SERVICE BULLETIN

ALL LEGACY'S STARTING WITH ENGINE #338575
AND SHORT BLOCK #765733 EXCEPT RHD/POSTAL
VEHICLES

LEGACY ENGINE BLOCK MODIFICATION/
A/C COMPRESSOR BRACKET MOUNTING BOLT CHANGE

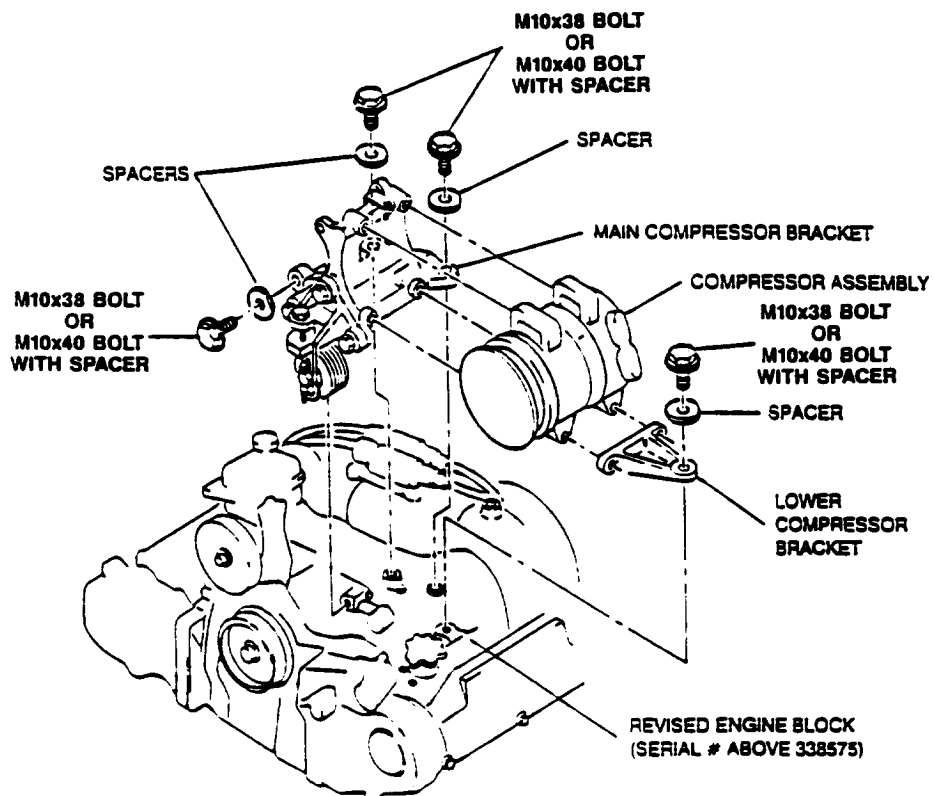
The Legacy engine block has undergone a change which decreased the A/C bracket bolt hole depth by 2mm. Shorter mounting bolts or spacer kits will be required when using A/C Kits P/N G3010AA000 and P/N G3010AA010 on production engines after Engine #338575 and after Engine #765733.

NOTE: When installing a modified engine block in an A/C equipped vehicle, a spacer kit or shorter mounting bolts must be used.

CAUTION: Damage to short block may result if spacer kit or shorter bolts are not used.

Spacer kits will be available separately through normal Parts channels by ordering P/N G3010AA020.

Revised A/C Kits P/N G3010AB000 and P/N G3010AB010 will initially have spacer kits supplied, a running production change will take place shortly thereafter, incorporating the shorter mounting bolts.
